**CITY OF GAINESVILLE PLANNING DIVISION  
SUMMARY OF COMMENTS**

<b>Petition Number: 192SUB-06 DB</b>	<b>Reviewed by: Gene G. Francis</b>
<b>Development Review Board Meeting: January 11, 2006</b>	
<b>Project Name/Description: Hidden Cove Subdivision Design Plat</b>

C0.20

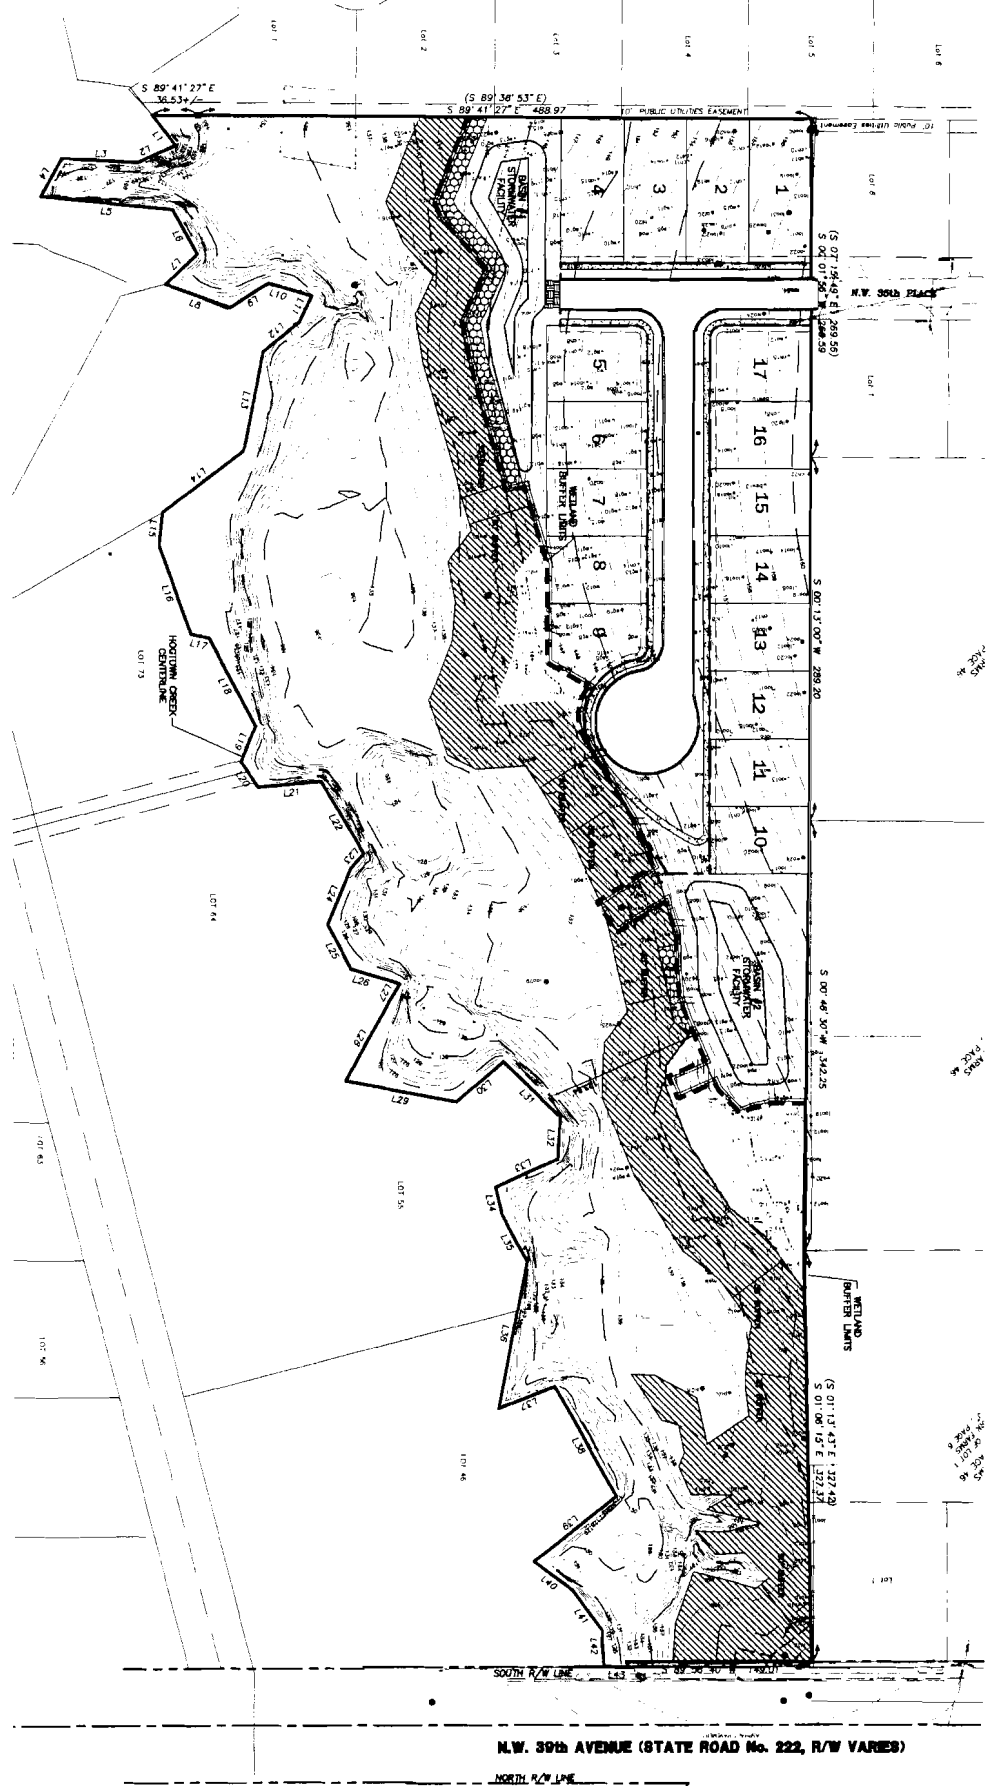
1. Planning staff would like for the petitioner to identify, more clearly, that the "Temporary" fence indicated on Sheet CO.20 and any other sheets where necessary, will be a 4-foot chain link fence.
